Modified Multi V-Belts

Problem:

Greatly enlarged view of the different profile sections

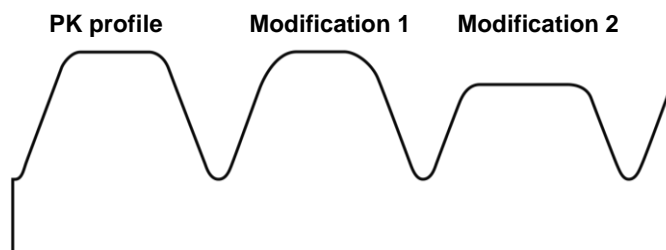
Multi V-belts that have been supplied differ optically and haptically from the conventionally used multi V-belts. The contact face has a different texture.

The modified profile section types – difficult to detect with the naked eye

These are modifications that either have been adopted from the original equipment or have arisen for reasons related to production operations. The aim is to achieve an optimal noise level and/or further improve the service life.

The modified belts can be used without reserve for the automotive applications specified in the catalog. Despite the optical differences, the new finish has no adverse impact on performance.
